Land at Bird in Eye Farm
South of Bird in Eye Hill
Uckfield

TRANSPORT ASSESSMENT ADDENDUM

ITR/MT/5330/TAA.4
March 2022

CLIENT	Croudace Homes Ltd.	DATE	11/01/22
PROJECT	Bird in Eye, Uckfield	DESIGN BY	MT
TITLE	Proposed Access Simple Priority T-Junction	DRAWN BY	ARM
		CHECKED BY	MT
DRAWING No.	5330 / 020	SCALE	1:1,000 @ A3
		REV No.	D

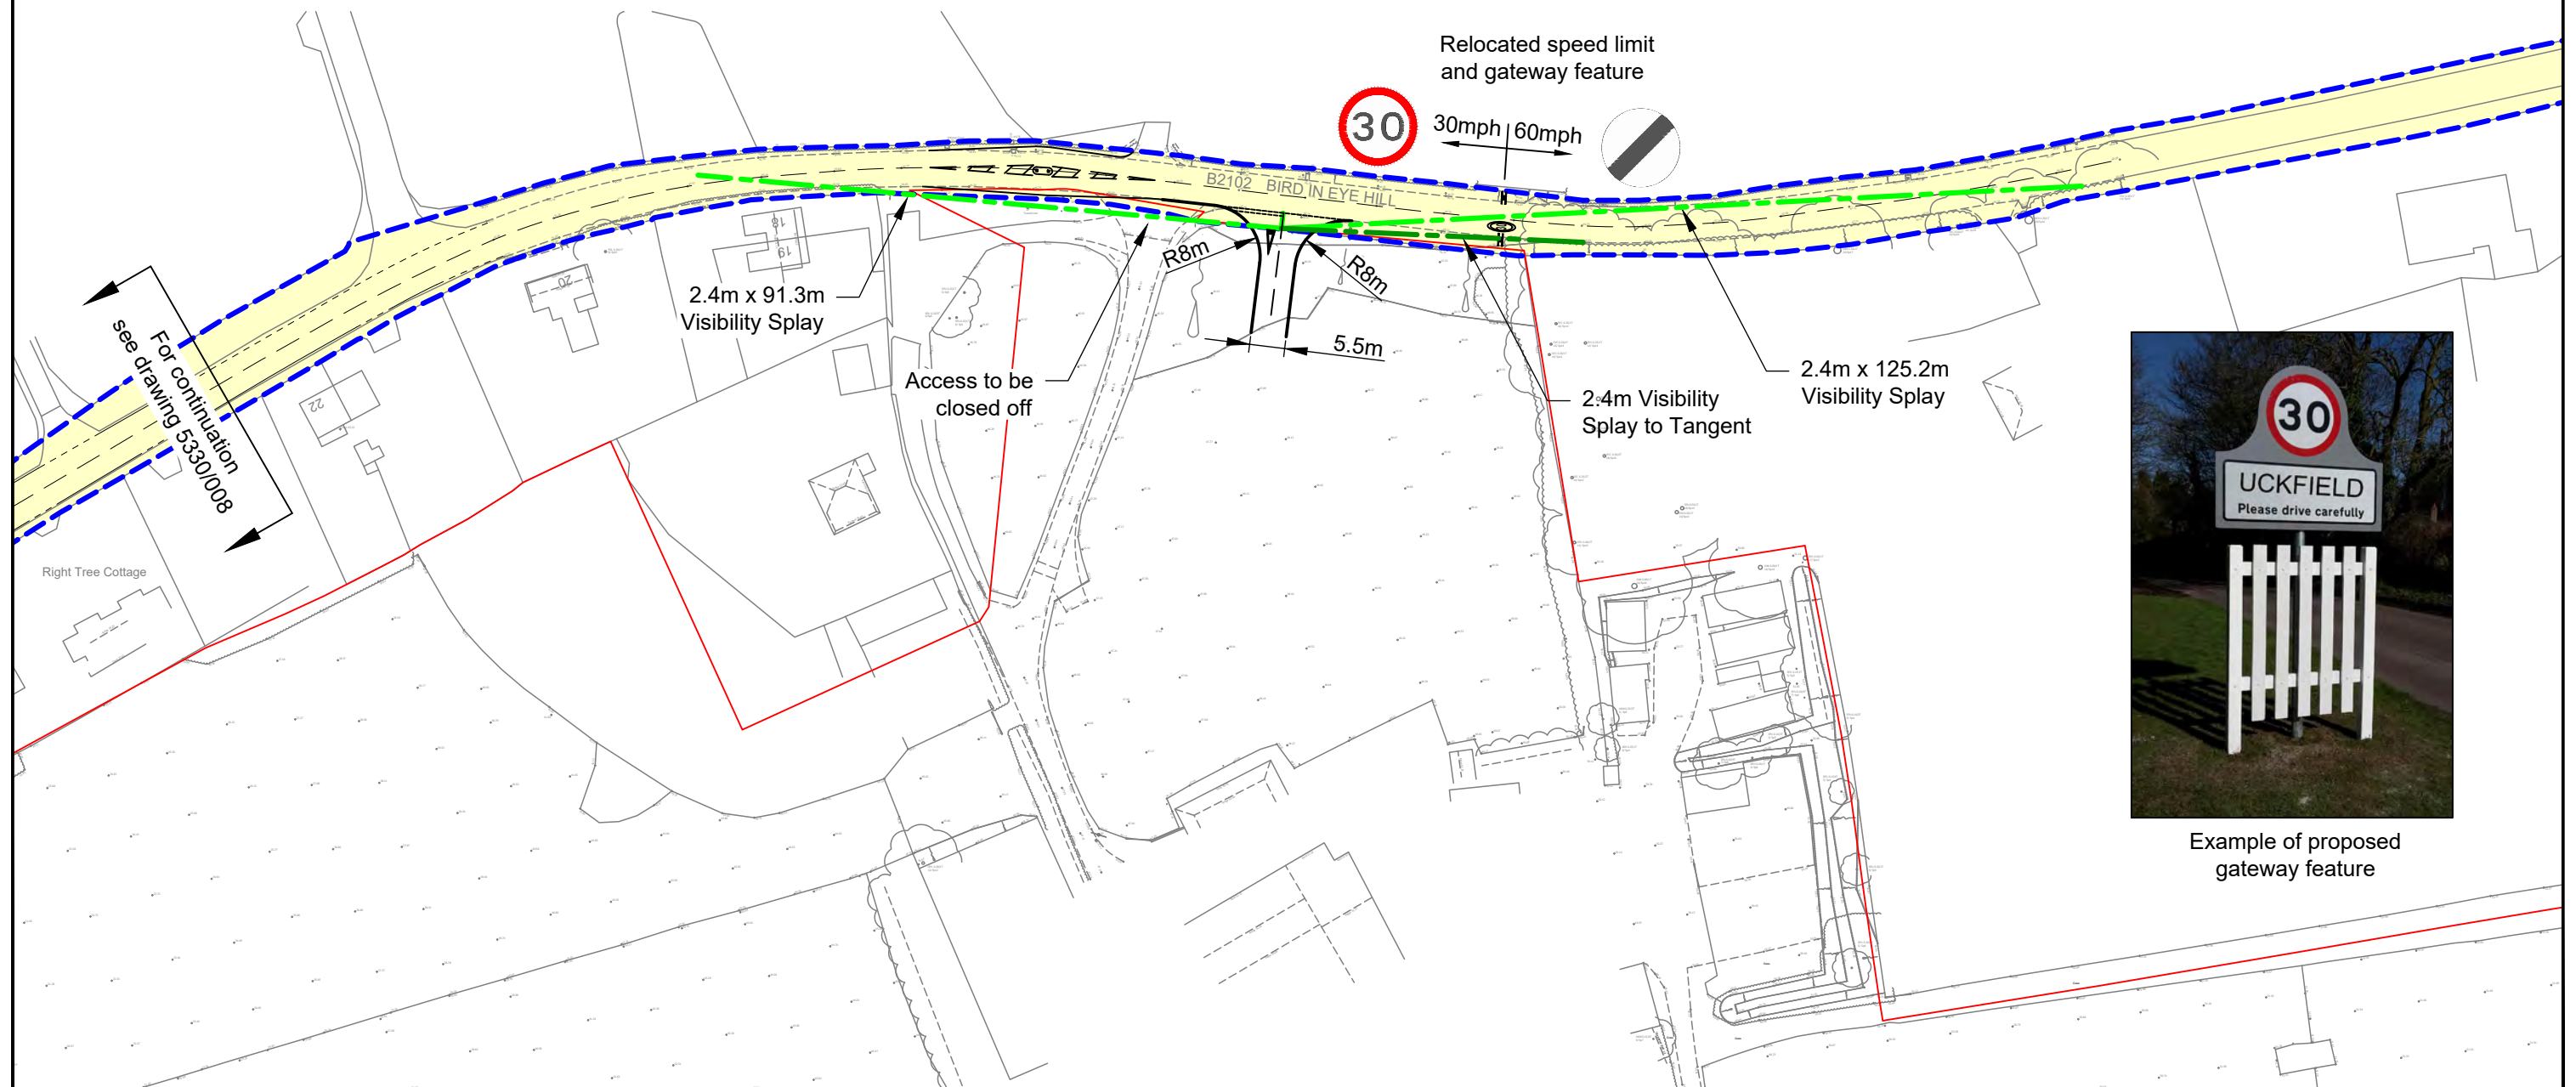
2.1 Vehicular access to the application site will be achieved directly from Bird in Eye Hill, via a simple priority T-junction. The Highway Authority has stated that a right turn lane is "recommended", given the distribution of traffic is predominantly weighted to and from the Framfield Road junction, west of the application site.

- 2.2** During the meeting of 12th January 2022, the Highway Authority advised that the request for a right turn lane had originated from the ESCC Traffic and Safety team who had requested this feature due to a concern regarding emergency vehicles travelling along Framfield Road from Uckfield Hospital being obstructed by vehicles turning right into the application site.

LHA Comment: Give way and centreline markings should be shown on the access plans.

- 2.3** The site access has been modelled using the PICADY Junctions 9 software. This modelling has been amended following comments from the Highway Authority and this is discussed in further detail later in this Addendum. However, the result of the modelling demonstrates that the proposed site access (simple priority T-junction) will operate well within capacity with very limited queuing and delay. Of particular note is the minimal queuing relating to vehicles turning right into the application site from Bird in Eye Hill. It is evident from this assessment that a simple priority T-junction is suitable to serve the proposed development, and a right-turn lane is not necessary.

2.16 To the east, visibility according to the desirable minimum distance required under DMRB guidance can be achieved. To the west, visibility in excess of the absolute minimum can be achieved. The proposed extension to the 30mph speed limit, and introduction of traffic calming features, will reduce traffic speeds and allow visibility splays to be provided in accordance with MfS guidance. See drawing 5330/020 rev. D, attached at **Appendix 4**.

BR Response: The access drawings have been updated to include all necessary road markings.

DRAWN BY ARM	DESIGN BY MT	CHK BY MT
DATE 30/04/20	DRAWING No. 5330 / 008	
SCALE 1:1,000 @ A2	REV No. E

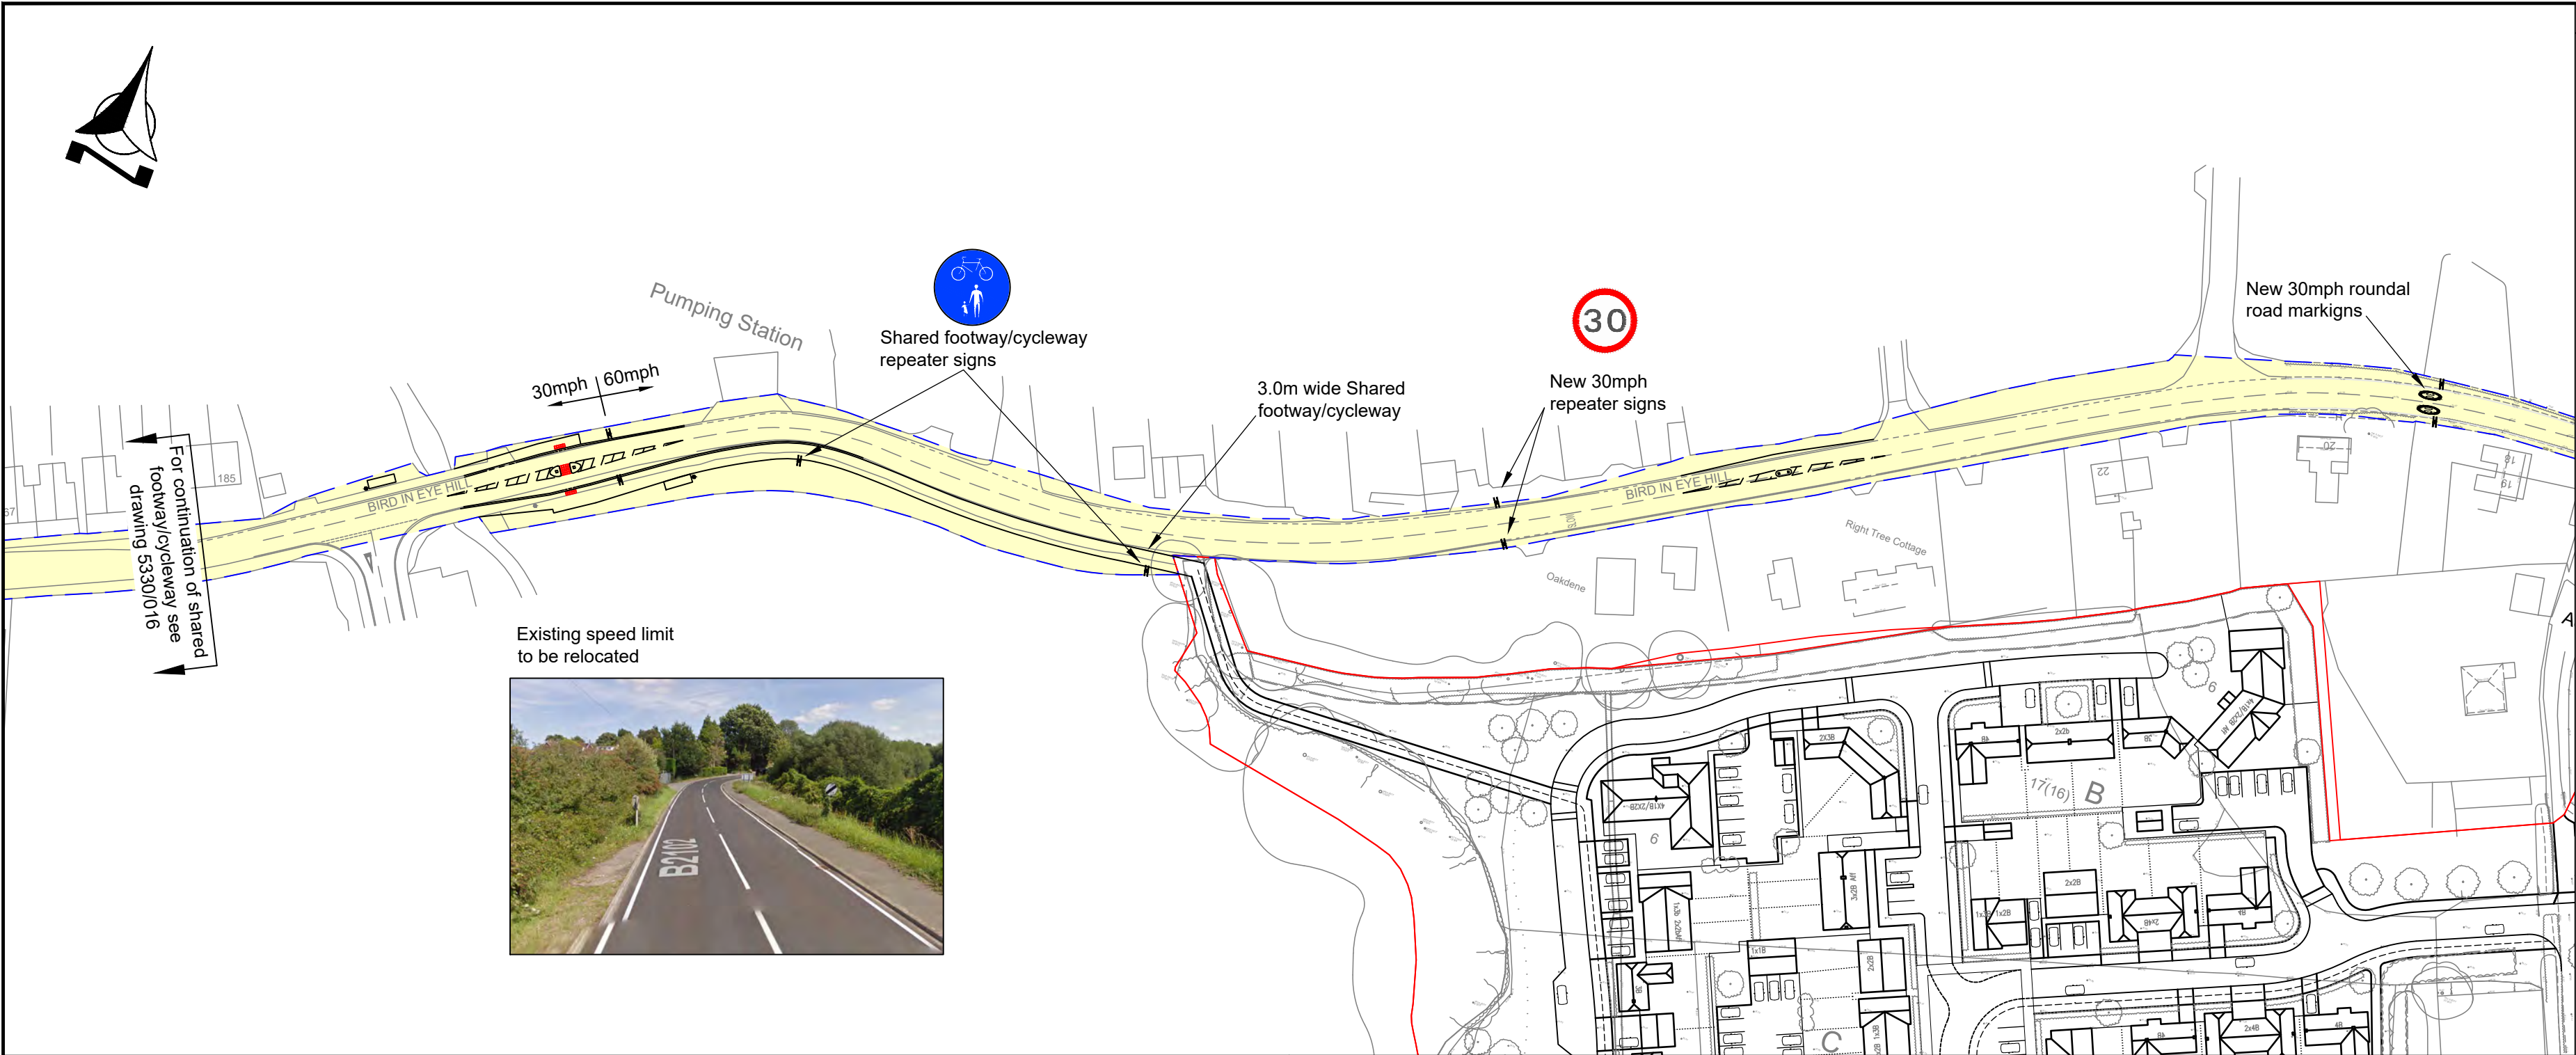
LHA Comment: The presence of an isolated island within a derestricted speed limit that is not supplemented by street lighting or frontage development may encourage middle of the road driving.

2.20 Nevertheless, the Highway Authority's comments are noted and to assist, it is proposed to introduce traffic islands along the length of Bird in Eye Hill between the site access and the location of the existing 30mph speed limit to reinforce the change in limit (see drawing 5330/008 rev. E, attached at **Appendix 5**).

BR Response: As set out previously, street lighting is not a prerequisite for installing a 30mph speed limit and frontage development exists to the west of the site access. Furthermore, the site access arrangement has been revised to include additional traffic islands to the west of the site access. This will change the nature and appearance of Bird in Eye Hill.
